SERVICE LETTER SL52 65-46010

1. Release Date: 11/17/2021
2. Service Letter No.: SL52 65-46010
3. Subject: Corrosion Preventive Sealant
4. Part/Assembly No.: 65-46010
5. Float Model Affected: 6650 on Daher KODIAK 100 AMPHIBIAN
6650 Model Floats, Serial Numbers – 184-185 and previous
6. Compliance: Mandatory Recommended Optional
7. Approval: All information provided is in accordance with approved data.
8. Corrective Action: Non-required.
9. Time Required: NA
10. Payments: Credit to Customer Under Warranty Customer Pays

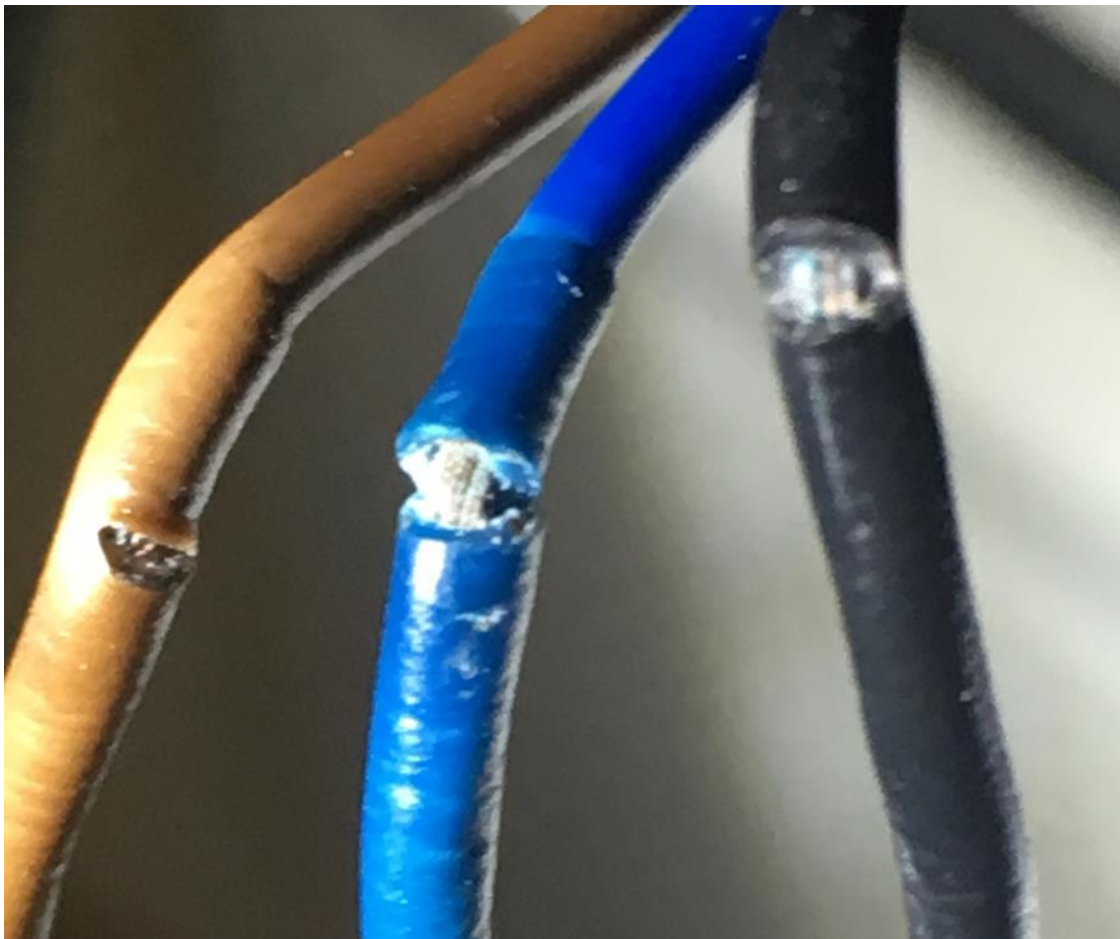
Small nicks in the insulation of wires when stripping external shielding from wire bundles can cause premature corrosion on wires. Aerocet recommends use of tin-and solder techniques for splices and terminations and use of corrosion-preventative sealant (See Table 1) with heat-shrink tubing for best performance.

The figure below shows where to inspect.

The pictures that follow are examples of what to look for.

1. Remove access panel at main landing gear to gain access to 65-46010 electrical wiring.
2. It may be required to remove wedge clamp(s) to assist with the visual inspection of the wire bundles.
3. Inspect the individual wires for cuts, nicks, etc. and corrosion where the shielding has been removed.
4. If damage or corrosion is found, replace wire set or affected section of wire.
